Comments on NRC Draft Screening Criteria for Assessing Potential Seismic Vulnerabilities of Spent Fuel Pools at Decommissioning Plants – December 3, 1999 NRC Memorandum

Seismic Screening Criteria
for
Assessing Potential Fuel Pool Vulnerabilities
at
Decommissioning Plants

Subject: Draft Final Technical Study of Spent Fuel Pool Accident Risk at
Decommissioning Nuclear Power Plants, February 22, 2000 (65 F.R.
8752), Request for Comments

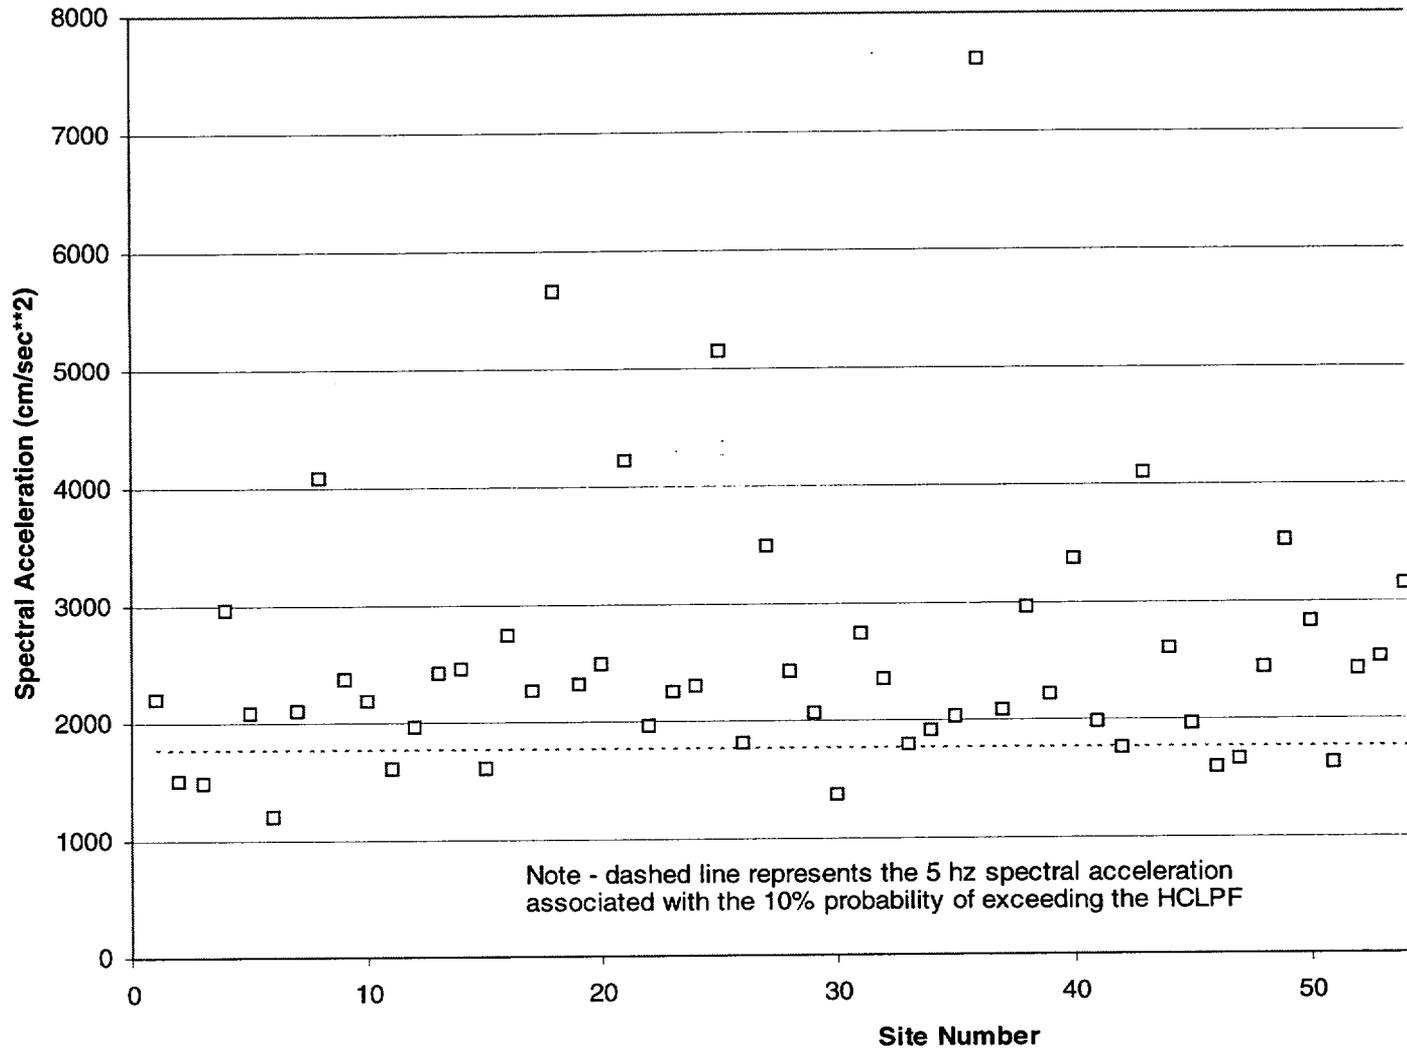
5. Figure 3 (Figure 2 from NUREG-1488, Reference 5) illustrates the problems associated with the LLNL results at high ground motions/low annual probabilities. As can be seen from Figure 3, at high probabilities there is reasonable agreement between LLNL and EPRI. However, the slope of the LLNL results at high ground motions is too shallow. The effect of this shallow slope is to predict incredible ground motions at credible probability levels.

LLNL 5 Hz Spectral Acceleration at 1.0E-6

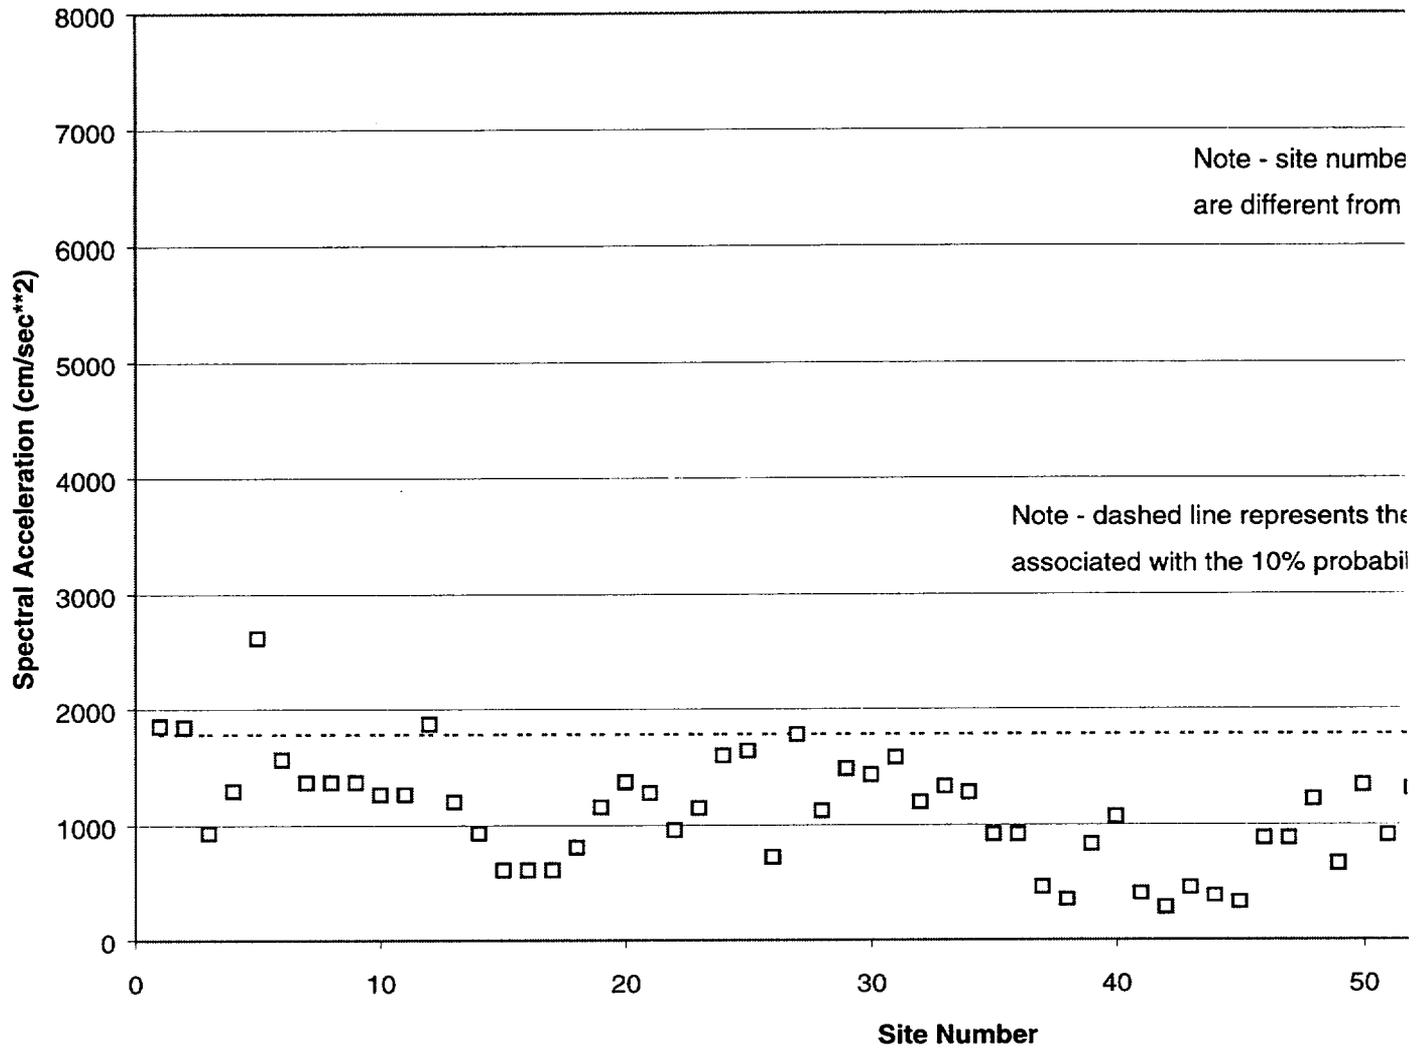
5. For a site to be screened out the $C_{10\%}$ value should be on the order of 10^{-6} . Figure 1 (attached) shows the 5 Hz spectral acceleration values associated with the 10^{-6} LLNL results at each of the 69 sites. As can be seen, for site number 36 (which in Table 3 of the Kennedy report is the site with the highest SFP failure frequency) the 10^{-6} spectral acceleration is about 7,700 cm/sec² or about 245 cm/sec. As stated previously, 57 cm/sec is consistent with 5 Hz spectral velocities associated with a magnitude 6.6 earthquake 8 km from the site (San Onofre SSE), therefore these predicted groundmotions must be associated with a very large earthquake, greater than magnitude 6.5, very near to the site – which is counter to the conclusions of SECY-91-135. Other values at other sites are equally incredible. Based on these results, it is concluded that the LLNL results, at the probability/ground motion levels of interest, are deterministically incredible and therefore their use in screening is questionable. Figure 2 (attached) shows the 5 Hz spectral acceleration values associated with the 10^{-6} EPRI results. As can be seen, the EPRI

EPRI 5 Hz Spectral Acceleration at 1.0E-6

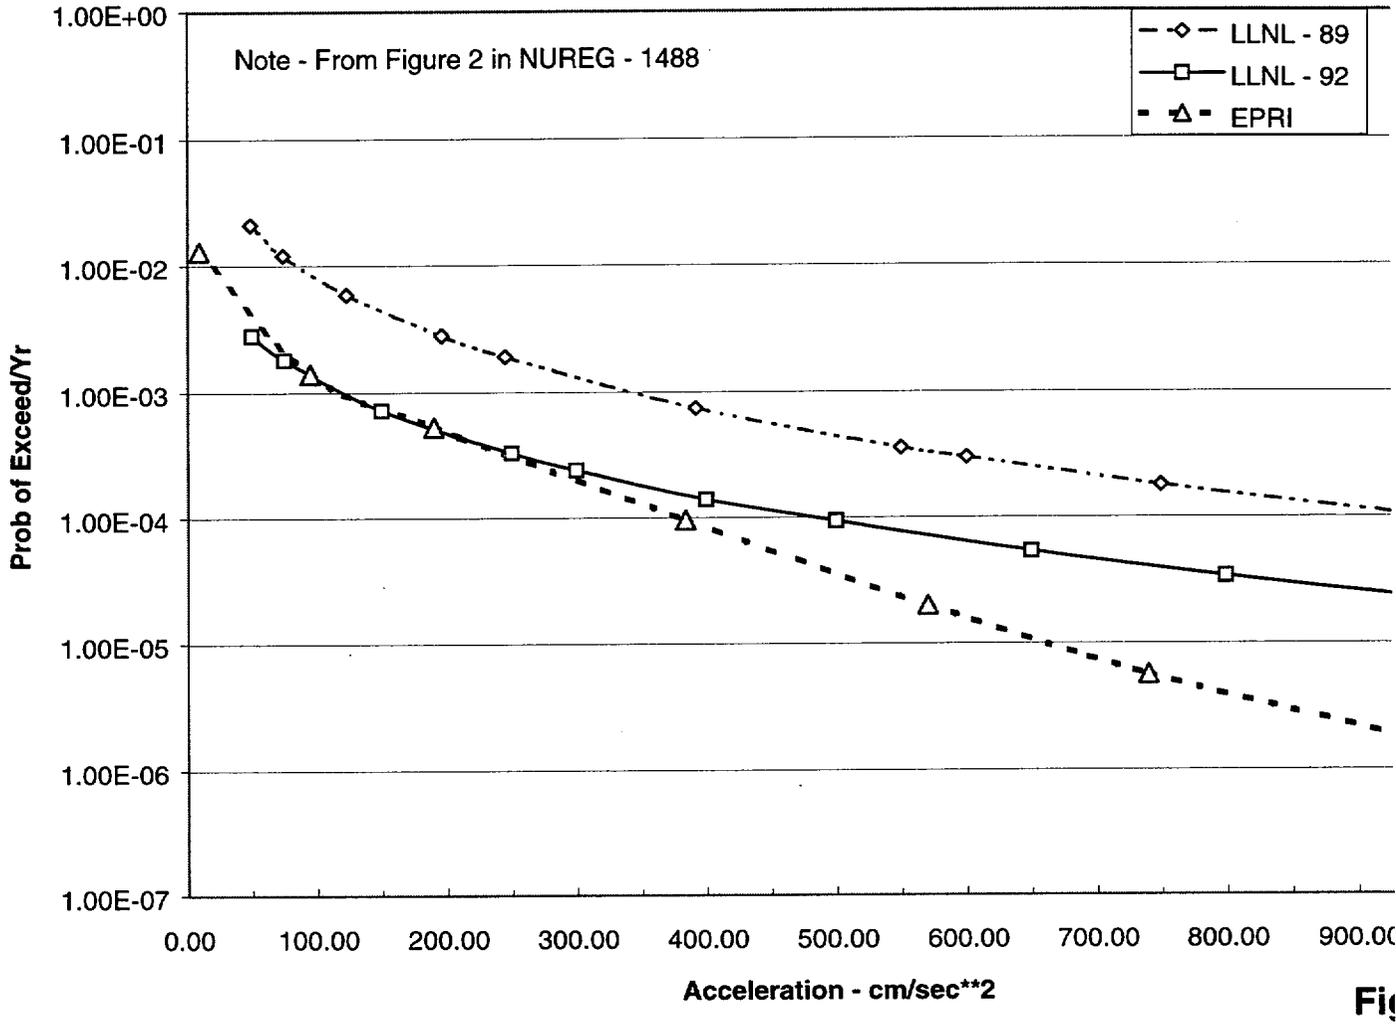
results, at the probability/ground motion levels of interest, are credible, and consistent with SECY-91-135.

Geometric Mean (LLNL & EPRI)

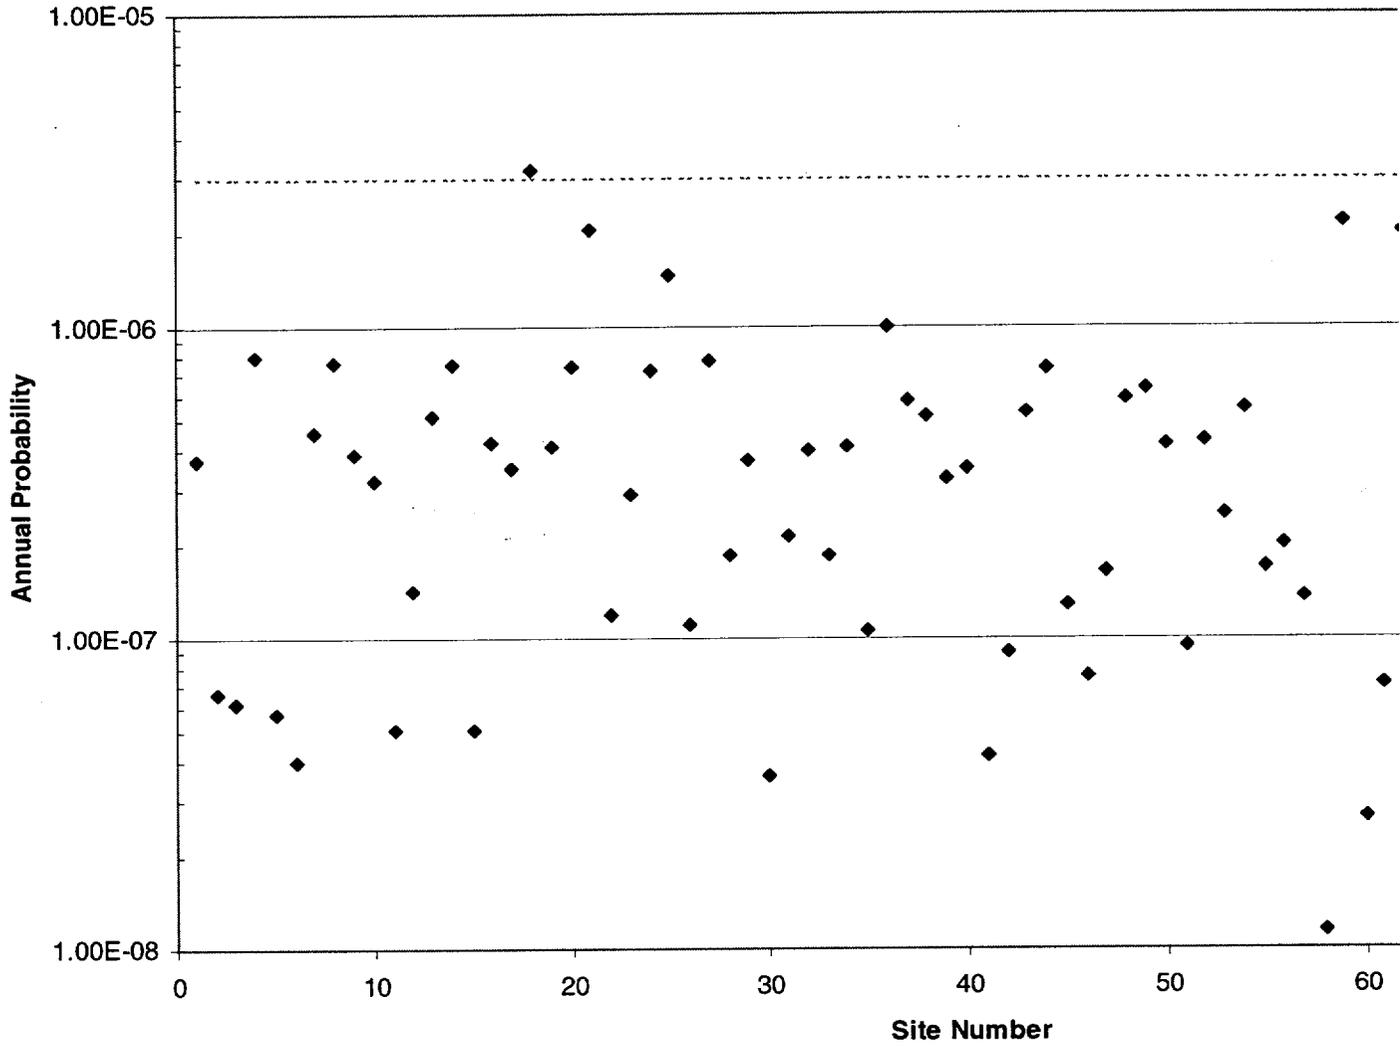
6. Based on this review, industry contends that it would be appropriate to only use EPRI results in the SFP seismic screening analysis. We believe this to be reasonable in light of the difficulties associated with the LLNL results at low probabilities. The effect of using only the EPRI results is shown in column 3 of Table 3 in the Kennedy report (Reference 1). As can be seen, only 1 plant would be required to perform further analyses. However, because both LLNL and EPRI are considered to provide valid results, it is proposed that the results from each study be geometrically averaged such that equal weight is provided the results from each study. Arithmetic averaging is considered unacceptable in light of the difficulties associated with the LLNL results. Figure 4 provides the results of geometrically averaging the LLNL and EPRI results.

Based on Figure 4 about 6 sites would be preliminarily screened in due to exceeding the 10^{-6} criterion. One of the 6 sites is Shoreham. If these screened in SFPs are above ground then further analyses will be required.

Figure 1 – Distribution of Upper Bound Magnitude Estimates from Reference 2 for a New England site.

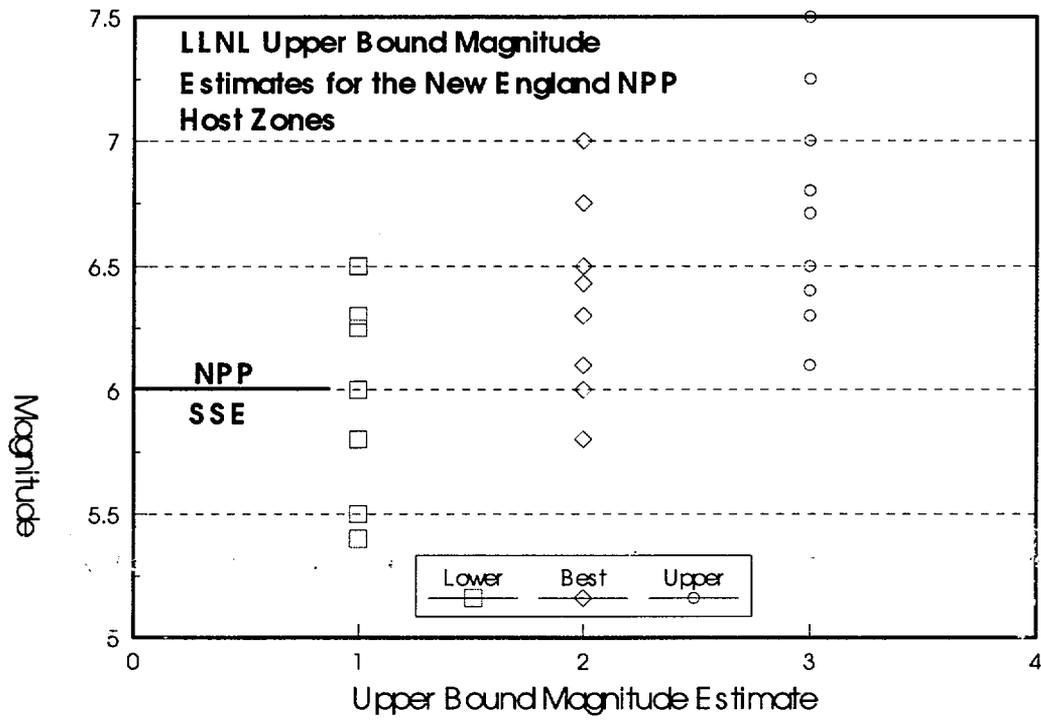
The conclusion that the SFP failure frequency is bounded by 3×10^{-6} per year can be found in previous submittals. In particular, it was shown that the assumption of a 0.5g HCLPF and applying Dr. Kennedy's conservative methodology to estimate SFP failure frequency at all CEUS sites using both the LLNL and EPRI seismic hazard results, the SFP failure frequency is bounded by 3×10^{-6} per year. It is noted that no distinction was made in the previous analysis concerning cases where 3 X SSE was greater than 0.5g. The basis for requiring a higher HCLPF value for plants with 3 X SSE greater than 0.5g is neither clear nor compelling. If the basis for requiring a higher HCLPF value for plants with high SSEs is that the SSE is assumed to be correlated with hazard it can readily be shown that seismic hazard and SSE are poorly correlated (Figure 3). Furthermore, it can be also be shown, using just the LLNL results and Dr. Kennedy's methodology, that there are many sites where 3 X SSE is greater than 0.5g **AND** the

Figure 3 – Annual Probability of Exceeding the SSE at CEUS sites based on EPRI (Reference 3)

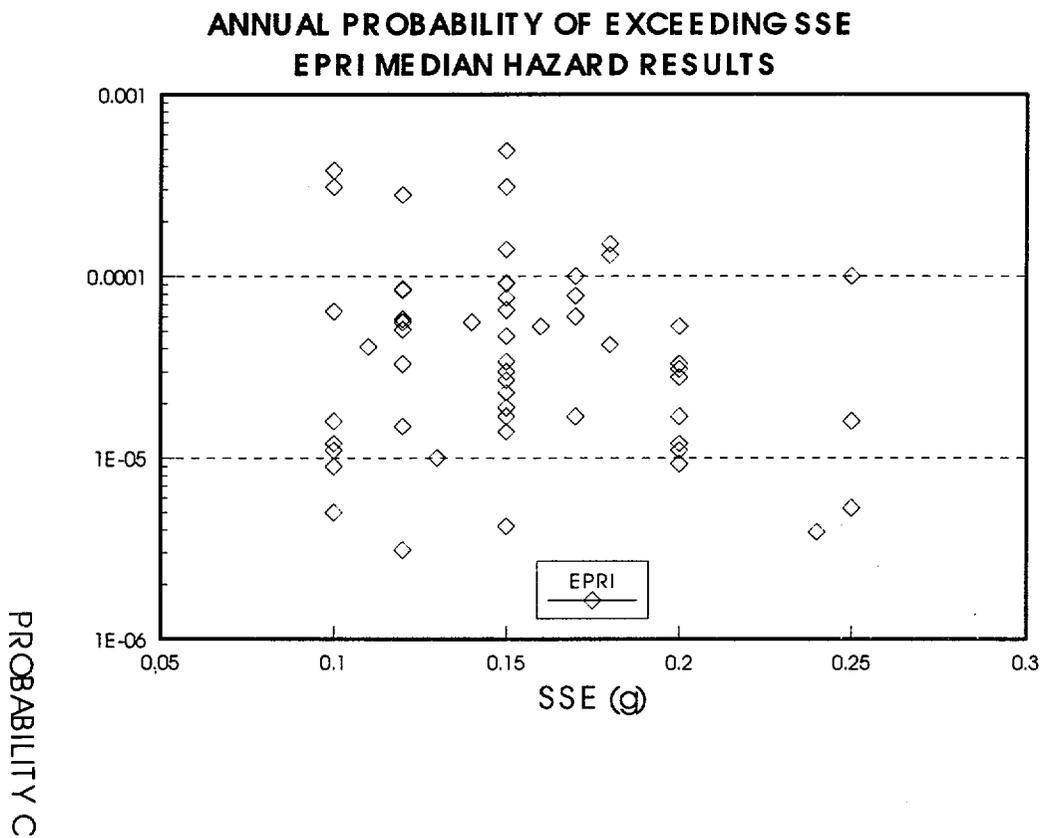
The basis for requiring a higher HCLPF value for plants with 3 X SSE greater than 0.5g is apparently the assumption that higher SSE levels are associated with higher seismic hazard levels - which is shown in the Appendix A to be an erroneous assumption. Furthermore, it has been previously shown, using just the LLNL results and Dr. Kennedy's methodology, that there are many sites where 3 X SSE is greater than 0.5g and the SFP failure frequency is well below those plants where 3 X SSE is less than 0.5g.
